RE: KOAT-TV (G16-D6). Carlisle and Comanche NE. Updated GRADING AND DRAINAGE PLAN FOR SITE DEVELOPMENT PLAN FOR BUILDING PERMIT APPROVAL AND FOR BUILDING PERMIT APPROVAL. ENGINEER'S STAMP DATED MARCH 5, 2001.

RE: KOAT-TV (G16-D6), Carlisle and Comanche NE. Updated GRADING AND DRAINAGE PLAN FOR SITE DEVELOPMENT PLAN FOR BUILDING PERMIT APPROVAL AND FOR BUILDING PERMIT APPROVAL. ENGINEER'S STAMP not DATED.

Project: BROADCAST FACILITY
Sheet Title: GRADING PLAN

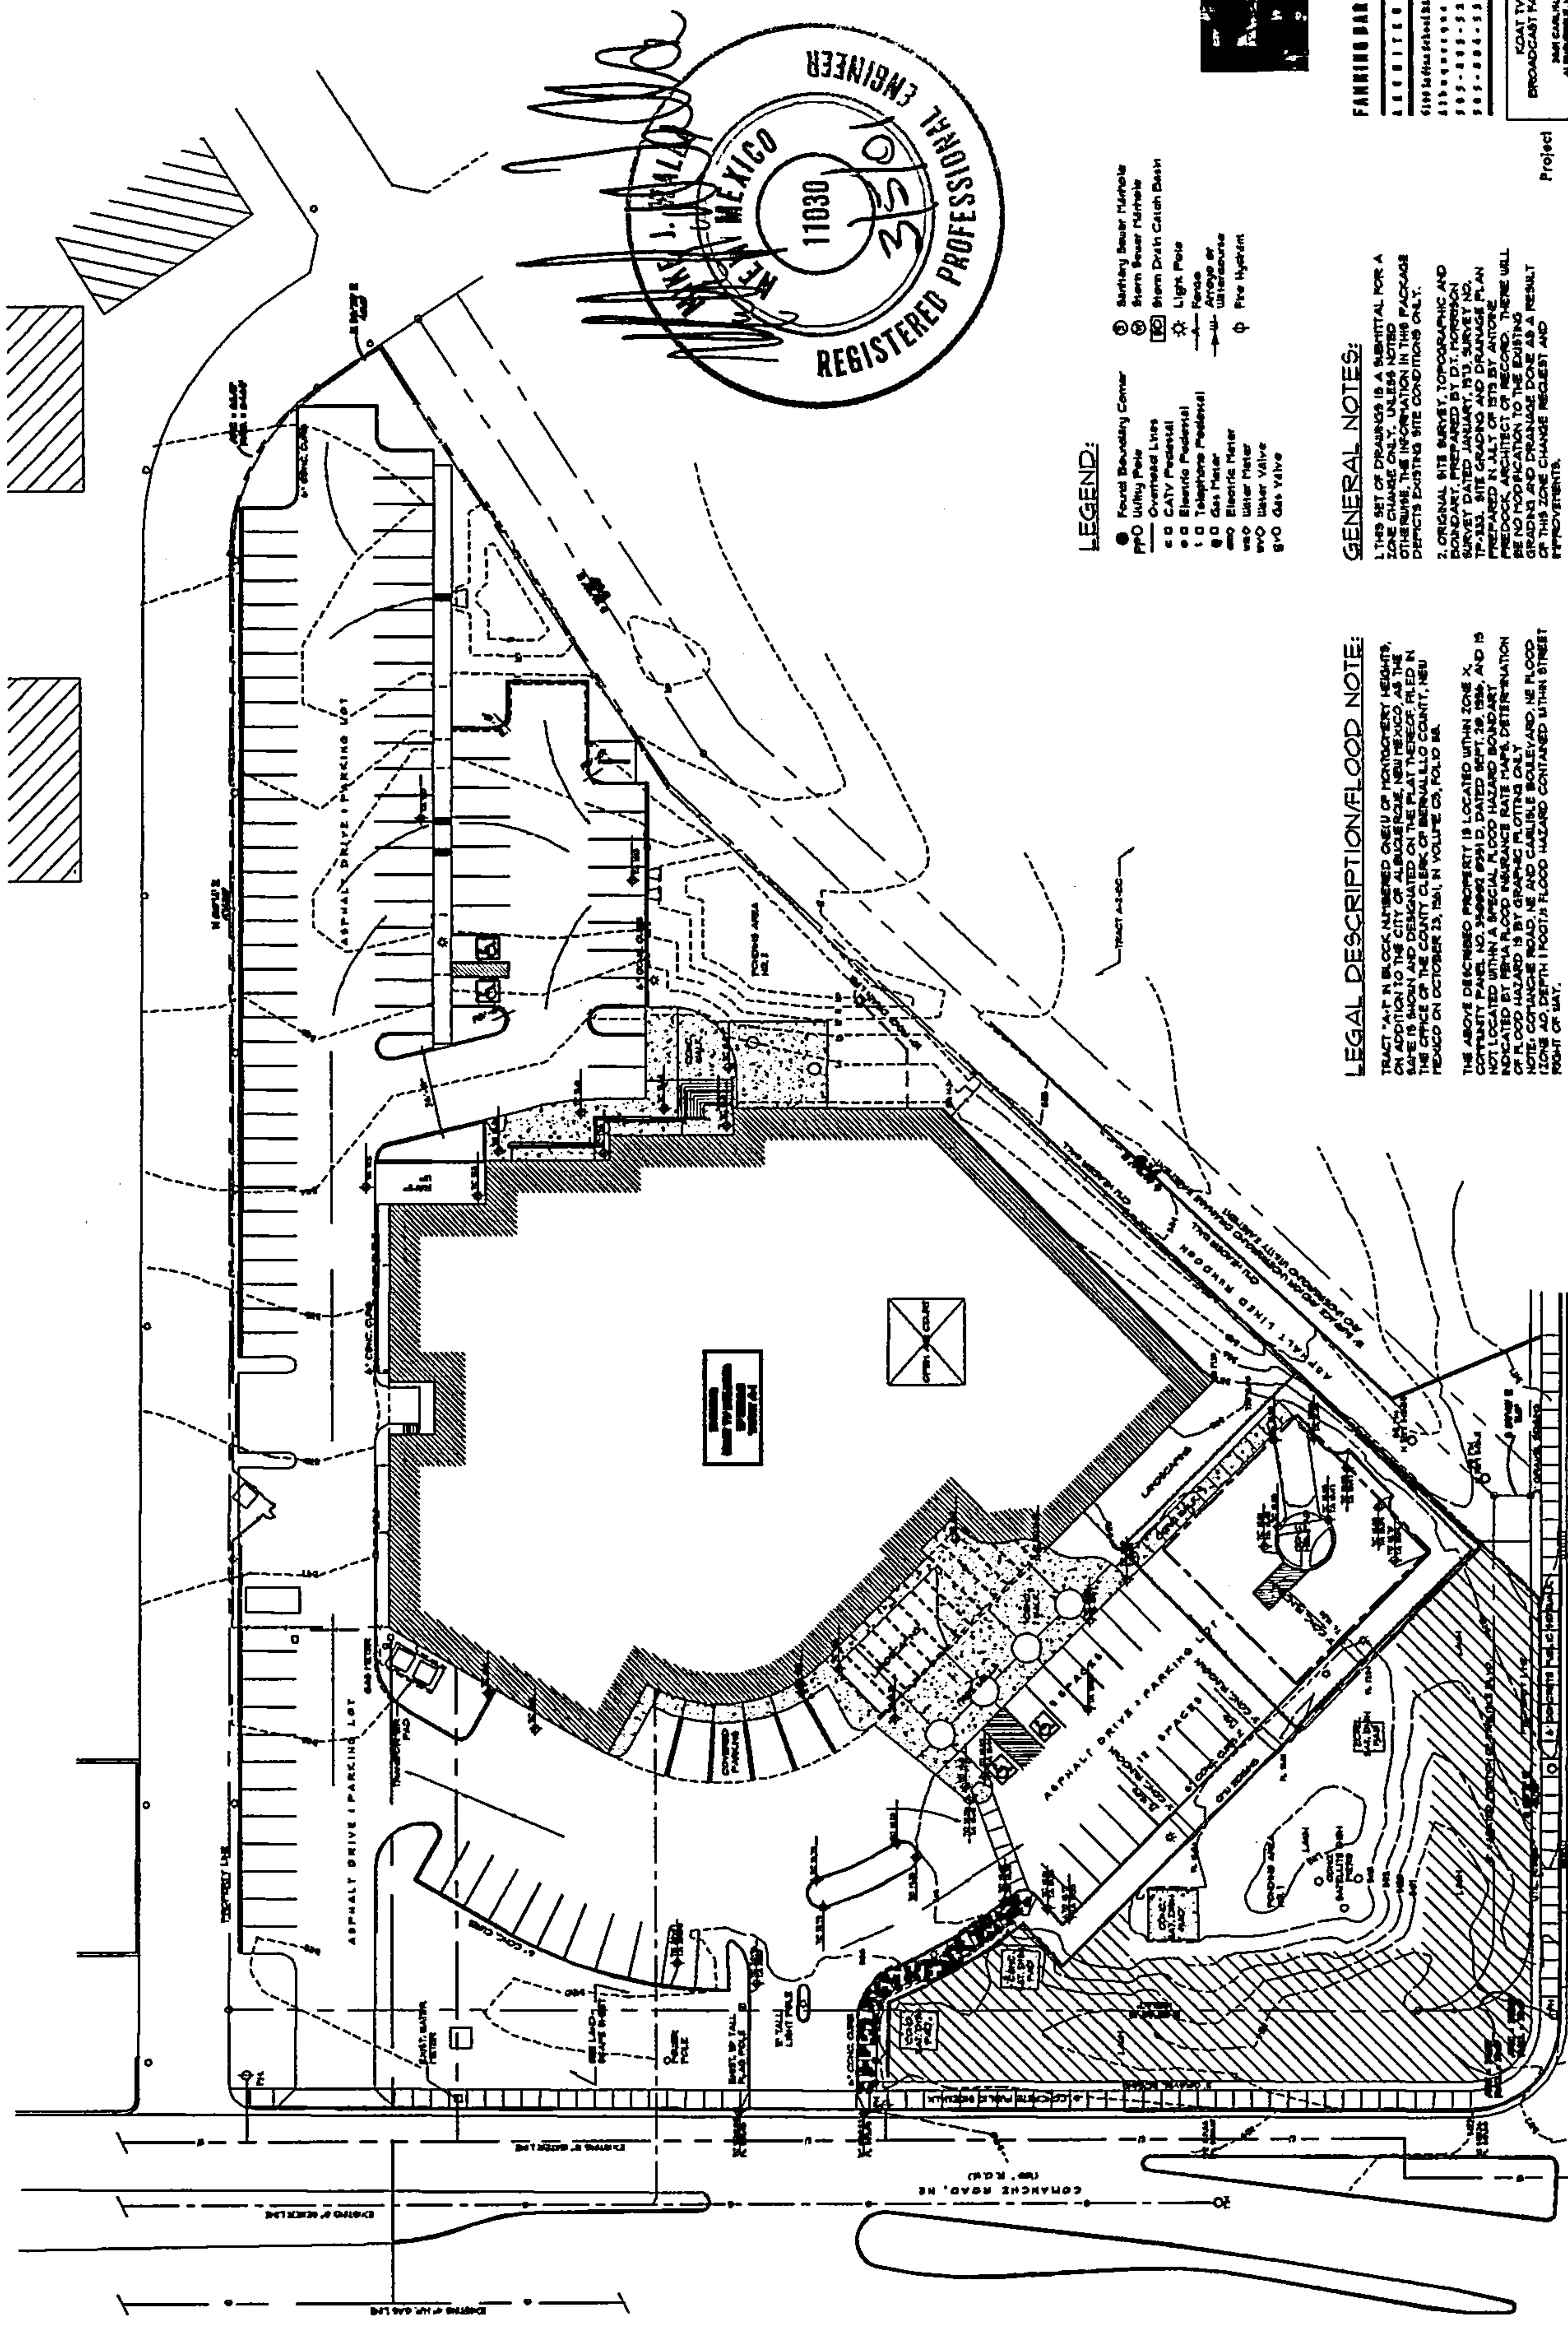
Based on the information provided on your March 6, 2001 submittal, the above referenced project is approved for both Site Development Plan for Building Permit and for Building Permit..

Please attach a copy of this approved plan to the construction sets prior to sign-off by Hydrology.

Prior to Certificate of Occupancy approval, an Engineer's Certification per the DPM will be required.

GRADING PLAN

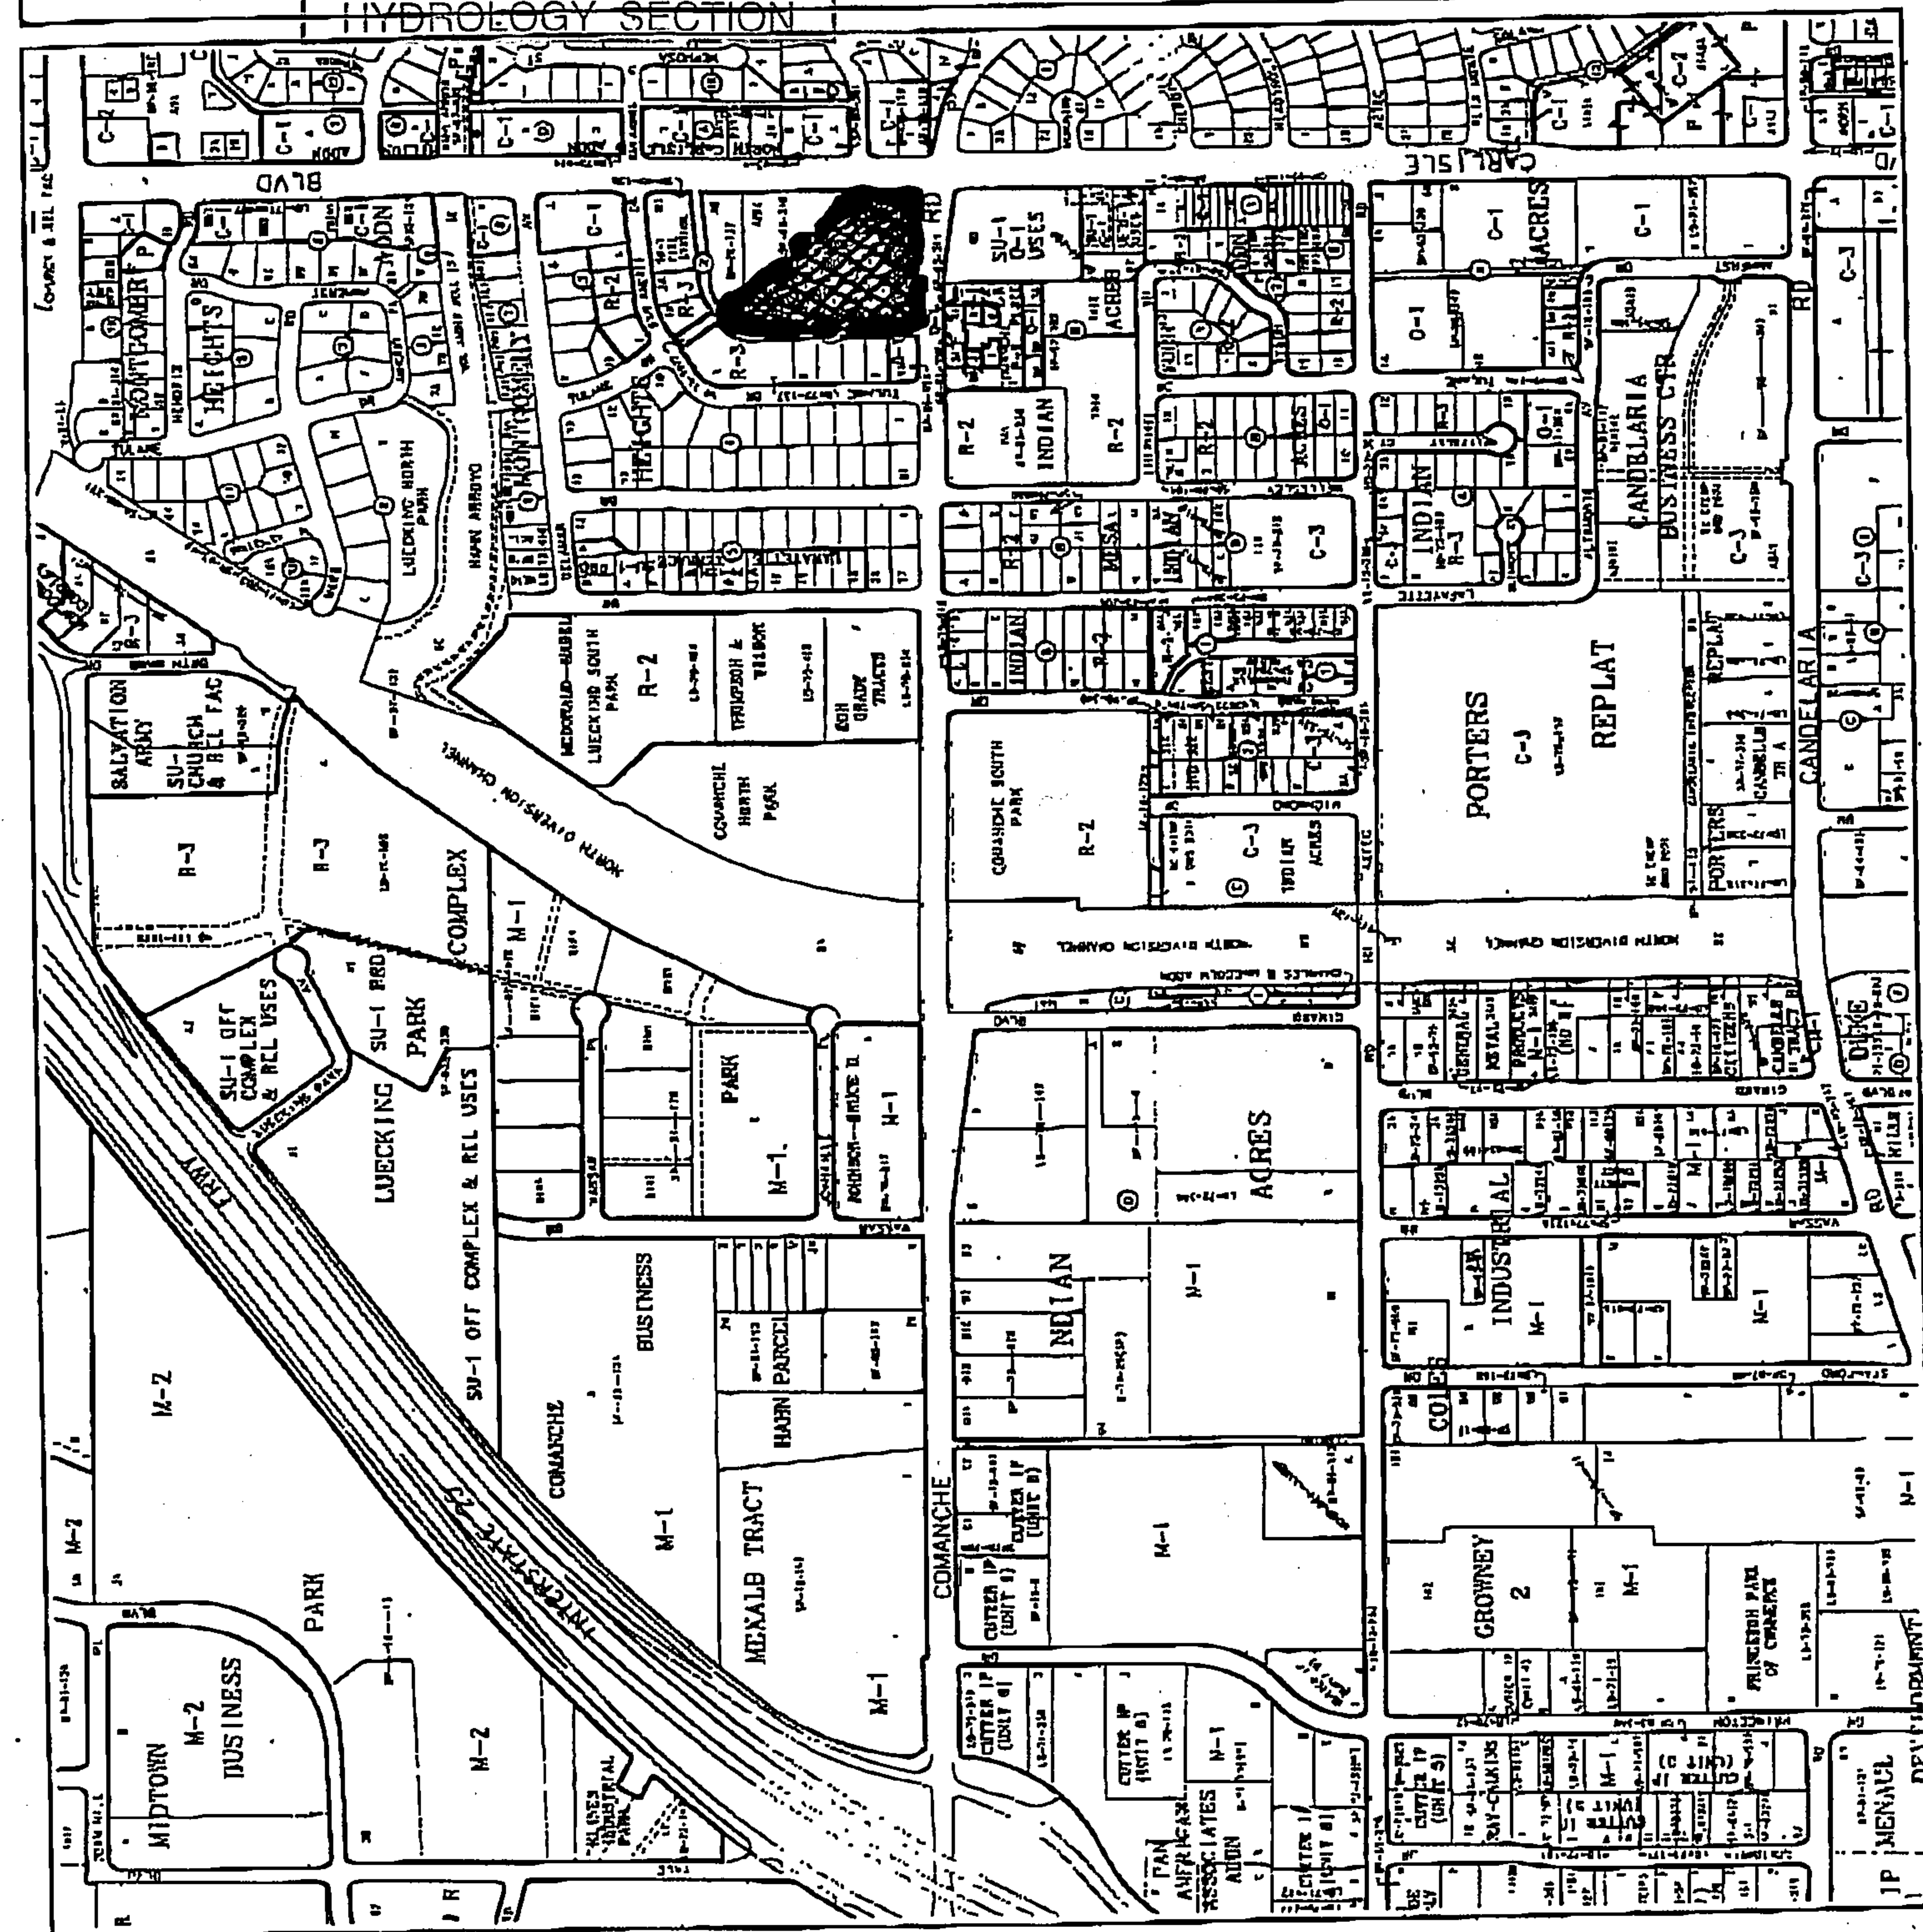
Based on the information provided on your March 2, 2001 submittal, the above referenced project will be approved for both Site Development Plan for Building Permit and for Building Permit with your Stamping & Dating the letter and plan.
